Access Compliance Report

Public Rights-of-Way

Intersection ID: 10027118	Main Street: GARDEN_DISTRICT_DR	Cross Street: N/A	Location: S
ADA ID: C91E16D28848	Ramp Type: Perp	Initial Pass/Fail: Fail	Overall Compliance: No
Severity Score: 25			
Codes/Mitigation Info/Possible Solution		Field Measurements/Component Compliance

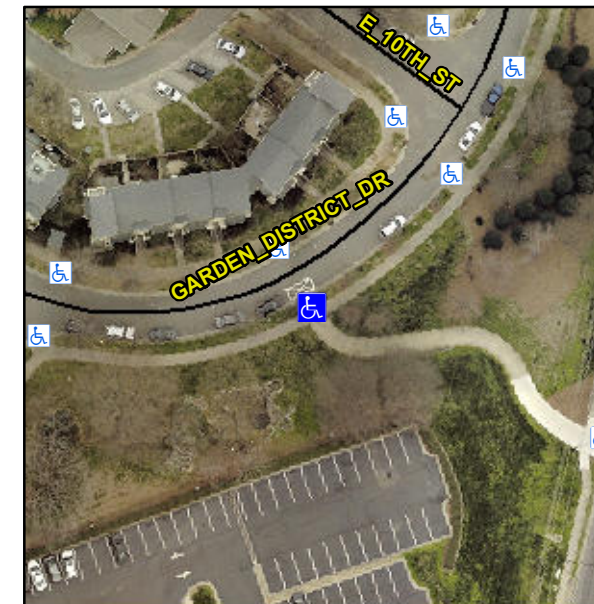
Not Found, R304.2.2, R304.5.3

Compliance	Description	Data	Compliance	Description	Data
N/A	Ramp Length (in)	75.0	No	Ramp Slope (%)	9.9
Yes	Ramp Width (in)	118.0	No	Ramp XSlope (%)	5.2
N/A	Flare Type LT	N/A	N/A	Flare Type RT	N/A
N/A	Flare Slope LT (%)	N/A	N/A	Flare Slope RT (%)	N/A
N/A	Flare Traversable LT?	N/A	N/A	Flare Traversable RT?	N/A
N/A	Landing Length (in)	N/A	N/A	DWS Provided?	N/A
N/A	Landing Width (in)	N/A	N/A	DWS Contrast?	N/A
N/A	Landing Slope (%)	N/A	N/A	DWS Length (in)	N/A
N/A	Landing X Slope (%)	N/A	N/A	DWS Full Width?	N/A
N/A	Landing Curb? (Y/N)	N/A	N/A	DWS Offset (in)	N/A
N/A	Shared Landing?	N/A			
N/A	Gutter Ponding?	N/A	N/A	Gutter Slope (%)	N/A
N/A	Gutter Lip Ht (in)	N/A	N/A	Gutter X Slope (%)	N/A
N/A	Painted X Walk1?	No	N/A	Painted X Walk2?	N/A
	X Walk 1 Direction	To N		X Walk 2 Direction	N/A
N/A	X Walk 1 Width (in)	N/A	N/A	X Walk 2 Width (in)	N/A
	X Walk 1 Slope (%)	4.3		X Walk 2 Slope (%)	N/A
	X Walk 1 X Slope (%)	5.4		X Walk 2 X Slope (%)	N/A

Remove & Replace Entire Ramp.
